REF: SUP-2006-24
DATE: August 8, 2024

| Request | - | Special Use Permit for scrap & salvage facility |
| Location | - | 5439 Lewis Avenue |

SPECIAL USE PERMIT
TOLEDO CITY PLAN COMMISSION
REF: SUP-2006-24
DATE: August 8, 2024
TIME: 2:00 P.M.

SITE PLAN

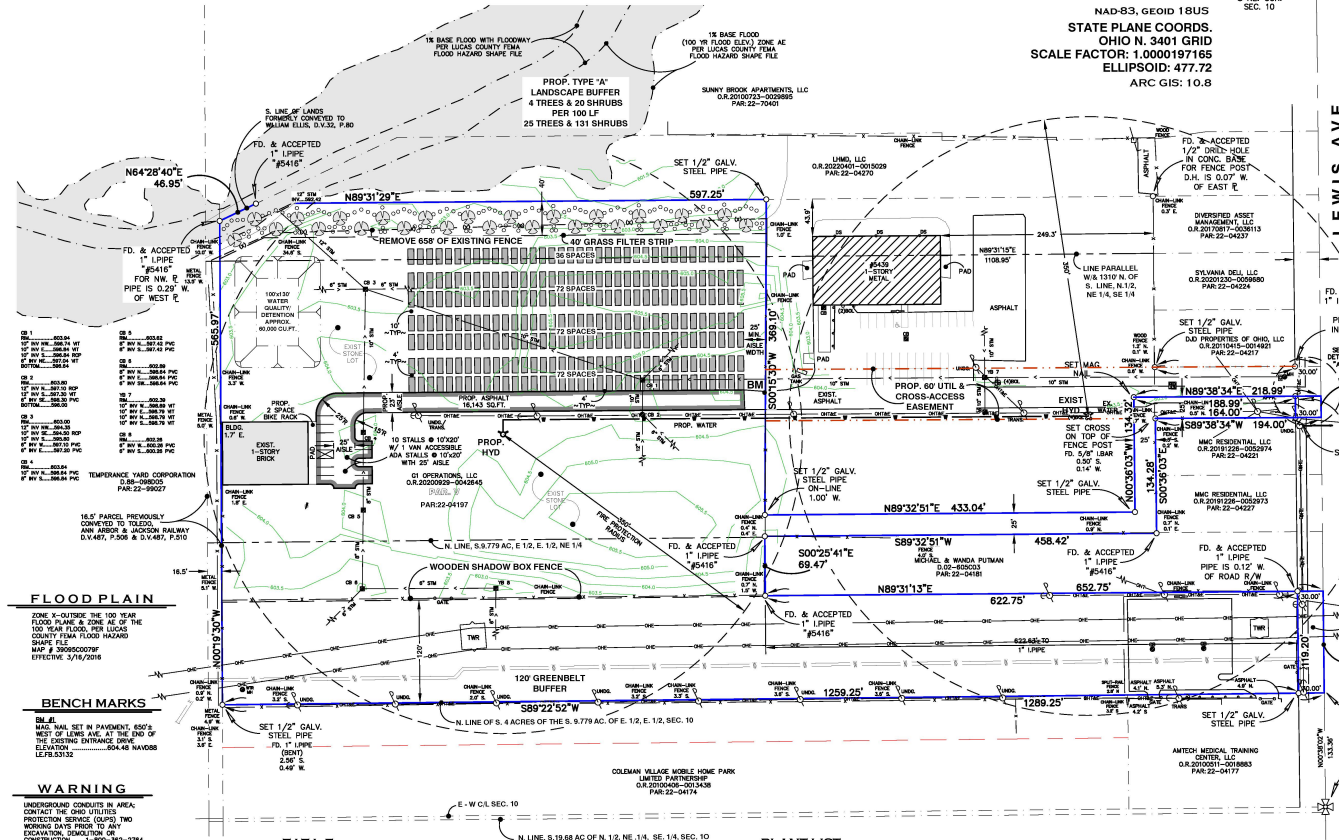
The applicant is proposing to pave the drive aisle and parking area with asphalt, and will seek a variance of TMC§1107.1900 from apply the Board of Zoning Appeals to allow gravel to remain on the rest of the site.

Scrap & salvage use requires one (1) parking space per acre. There is a bus stop in front of the site, which as per TMC§1107.0407(E), reduces the required number of parking spaces by 20%. With this reduction, the 10.8-acre site requires eight (8) spaces. The site plan depicts a total of eleven (11) parking spaces, including one (1) van-accessible space with an eight-foot (8') aisle.

Bicycle parking is also required pursuant to Off-Street Parking Schedule "A" (TMC§1107.0300). A minimum of one (1) bicycle space shall be provided per each ten (10) parking spaces. As per TMC§1107.0901(B), the minimum number of slots provided shall be two (2). A bicycle rack with two (2) slots is provided on the site plan. The proposed parking plan is acceptable as depicted.

The southern ±120 feet of the site contains an Edison easement with two electrical towers. The site plan depicts this area as a "greenbelt buffer," though no additional landscaping can be added within this space per the easement. If the site plan is approved, the easement shall remain free of all storage related to the scrap & salvage operation.

Per TMC§1108.0202 – *Frontage Greenbelts*, sites over five (5) acres are required to provide a thirty-foot (30') frontage greenbelt and contain at least one (1) tree for every thirty feet (30') of frontage. The property has two (2) frontages on Lewis Avenue for a total of 144'. The northern leg has twenty-five feet (25') of frontage on Lewis Avenue, all of which is driveway. The southern leg is comprised of the Edison easement, as mentioned, and cannot be planted with additional landscaping. The site is unable to meet the requirements of TMC§1108.0202, therefore the applicant shall request a waiver for this requirement.

A Type A Landscape Buffer is required along the northern, southern, and eastern edges of the property where abutting residential uses. This buffer must be ten feet (10') wide and contain four (4) trees and fifteen (15) shrubs with fencing per 100 linear feet. Alternatively, the buffer can exclude fencing if it is twenty-five feet (25') wide with four (4) trees and twenty (20) shrubs

per 100 linear feet. Due to the Edison easement and narrow driveway, this requirement can only be implemented along the northern edge of the site. The site plan depicts a forty-foot (40') wide Type A Buffer with 25 trees and 131 shrubs along the northern edge of the site, which is acceptable as depicted. The applicant will request a waiver of the Type A Buffer along the southern and eastern edges of the site.

In addition, a Type B Buffer is required where Industrial Zoning Districts abut Commercial Zoning Districts. This requirement pertains to the southeast of the site where it abuts a CR-Regional Commercial zoning district. A Type B buffer should be comprised of four (4) trees and fifteen (15) shrubs per 100 linear feet. The applicant will request a waiver for this requirement as well, due to the limitations of planting within the Edison easement.

In lieu of the required buffers, the applicant is requesting that the Plan Commission allow the Edison easement to act as a natural buffer between adjacent residential and commercial uses. In addition, the applicant has proposed a fence along the northern edge of the easement to add additional screening for the site. The Planning Director has indicated this would be an acceptable compromise if the Special Use Permit is approved. Fencing materials shall be opaque (either wood or vinyl in an earth tone) and will be subject to final approval from the Planning Director. Additionally, the fence was originally depicted as ending at the western edge of the adjacent parcel with the auto repair shop (#2204181); however, staff requested that this fence be extended along the southern edge of the entire length of the driveway where the subject parcel abuts legal nonconforming duplexes. This fencing will provide screening of the subject site for the mobile home park to the south, the duplexes to the east, as well as the Day Care Center that abuts the site to the southeast. The fence extension is shown on the applicant's revised plan and is acceptable as depicted.

Per TMC§1108.0203(H), outdoor storage screening is required in all Industrial Districts. This code section allows shadow box, chain link with slats, or stockade. The proposed fence will satisfy this requirement along the south and eastern portion of the site; however, the existing chain link fence along the northern edge of the site requires the addition of earth tone slats to screen the properties to the north. This detail shall be included on a revised landscape plan. No buffer or screening is required between the site and the adjacent IG-General Industrial parcel to the west.

Parking lot landscaping is not required for IG-General Industrial zoning districts unless abutting residential uses. Given the site is surrounded by residential uses, both interior and exterior parking lot landscaping is required. Per TMC§1108.0204(B)(1), twenty (20) square feet of interior landscaping is required per parking space. With eleven (11) parking spaces, the site is required to have 220 square feet of interior landscaping, comprised of two (2) canopy trees and six (6) shrubs (TMC§1108.0204(C)(1)). This landscaping shall be shown on a revised plan.

Perimeter landscaping comprised of one (1) canopy tree per each thirty (30) linear feet, as well as a continuous shrub row, is also required along any parking lot area adjacent to a street, place, or driveway, or which is visible from an immediately adjacent property. This requirement pertains to the eastern edge of the site where there are abutting nonconforming duplexes; however, the narrow driveway prevents any additional landscaping in this area of the site. The applicant shall request a waiver of the five (5) required trees along the ±134' length abutting the duplexes.

Per TMC§1108.0205, interior site landscaping is required in IG-General Industrial districts when they abut a residential use. One (1) 2-inch caliper tree is required for every 2,000 square feet of building coverage, which computes to the need for (4) trees for this site given the building's footprint (±7,344 square feet). Additionally, landscaping is required at all major building entrances. Four (4) trees, as well as plantings along the building's main entrance, shall be shown in a revised landscape plan.

5. Site grading in the northeast quadrant shows an existing nonconformance of stormwater surface runoff across the property line; a Special Use Permit would not be a permanent waiver of TMC 1107.1906, which requires internal drainage. The proposed filter strip may improve the nonconformance. The Ohio Rainwater Manual defines a grass filter strip for stormwater treatment as a broad, pervious area of healthy vegetation and high soil quality on a mild, uniform slope of maintained turf-forming grasses applied between the impervious surface and storm drainage conveyance infrastructure. The manual notes a filter strip or conservation area alone does not achieve water quality goals and cannot serve as a development's exclusive or primary practice to manage the water quality volume (WQV) except to treat small pockets within a development (excluding pollutant hot spots) that cannot otherwise be directed to a standard practice.

6. In the stream's riparian area, the Ohio Rainwater Manual prescribes setbacks for development rather than filter strips; therefore, it is recommended to delete the proposed filter strip where it coincides with the flood hazard zone and the riparian area. Should the

33. Per TMC§1107.0600 – Off-Street Parking Schedule “A”, the minimum number of parking spaces required for a scrap & salvage operation is one (1) per acre. The site is 10.8 acres. With the 20% reduction of TMC§1107.0407(E) for the bus stop adjacent to the parcel, the site requires eight (8) spaces. **Acceptable as depicted with ten (10) standard parking spaces.**

34. Any spaces reserved for the use by persons with physical disabilities shall adhere to the standards outlined in TMC§1107.1700. One (1) van-accessible space is required. **Acceptable as depicted with one (1) van-accessible space provided.**

35. Per TMC§1107.0400, Off-Street Parking Schedule “A” requires one (1) bicycle parking slot per ten (10) parking spaces. **Acceptable as depicted with two (2) slots.**

- a. A thirty-foot (30') frontage greenbelt is required along Lewis Avenue that includes one (1) tree per every thirty feet (30') of frontage; **Not acceptable as depicted. The site is unable to meet TMC§1108.0202, therefore the applicant shall request a waiver for this requirement.**

- b. A Type A Landscape buffer shall be provided where Industrial Zoning Districts abut residential uses. A Type A Landscape Buffer requires four (4) trees and fifteen (15) shrubs with fencing per 100 linear feet, or four (4) trees and twenty (20) shrubs without fencing; **The site plan depicts a forty-foot (40') wide Type A Buffer with 25 trees and 131 shrubs along the northern edge of the site, which is acceptable**

as depicted. The applicant will request a waiver of the Type A Buffer along the southern and eastern edges of the site. Due to the restrictions of the easement along the southern edge of the site, an opaque fence will be provided to the north side of the easement, extending north along the western edge of parcel #2204181, running the length of the depicted driveway. The fence shall be wood or vinyl in earth tones and will be subject to final approval from the Planning Director. This fencing will provide screening of the subject site for the mobile home park to the south, the duplexes to the east, as well as the Day Care Center, zoned CR-Regional Commercial, that abuts the site to the southeast.

- c. A Type B Landscape buffer shall be provided where Industrial Zoning Districts abut Commercial Zoning Districts. Buffer shall include four (4) trees and fifteen (15) shrubs per 100 linear feet; **Applicant shall request a waiver of this requirement. As mentioned in the above condition (b), the proposed fencing along the northern edge of the easement will be extended to provide screening for the Day Care Center, zoned CR-Regional Commercial, that abuts the site to the southeast.**

- d. In all Commercial and Industrial districts, fencing to screen from public view open storage areas shall be required as outlined in TMC§1108.0203(H). Fencing shall be at least six feet (6') in height and be shadow box, chain link with slats, or stockade. **Not acceptable as depicted. Existing chain link fencing along the northern edge of the site requires the addition of earth tone slats to screen the properties to the north. This detail will be included in a revised landscape plan.**

- e. Per TMC§1108.0204(B)(1), twenty (20) square feet of interior landscaping is required per parking space, as the site is abutting residential uses. **Not acceptable as depicted. With eleven (11) parking spaces, the site is required to have 220 square feet of interior landscaping, comprised of two (2) canopy trees and six (6) shrubs (TMC§1108.0204(C)(1)). This landscaping shall be shown on a revised landscape plan.**

- f. Perimeter parking lot landscaping shall be installed along any parking lot area adjacent to a street, place, or driveway and shall be provided abutting the parking area to visually screen all off-street loading facilities from view of public rights-of-way. A continuous shrub with a minimum height of eighteen inches (18") is required; **Not acceptable as depicted. This requirement pertains to the eastern edge of the site where there are abutting nonconforming duplexes; however, the narrow driveway prevents any additional landscaping in this area of the site. The applicant shall request a waiver of the five (5) required trees along the ±134' length abutting the duplexes.**

- g. Per TMC§1108.0205, interior site landscaping is required in IG-General Industrial districts when they abut a residential use. One (1) 2-inch caliper tree is required for every 2,000 square feet of building coverage, which computes to the need for (4) trees for this site given the building's footprint ($\pm 7,344$ square feet). Additionally, landscaping is required at all major building entrances. **Not acceptable as depicted. Four (4) trees, as well as plantings along the building's main entrance, shall be shown in a revised landscape plan.**
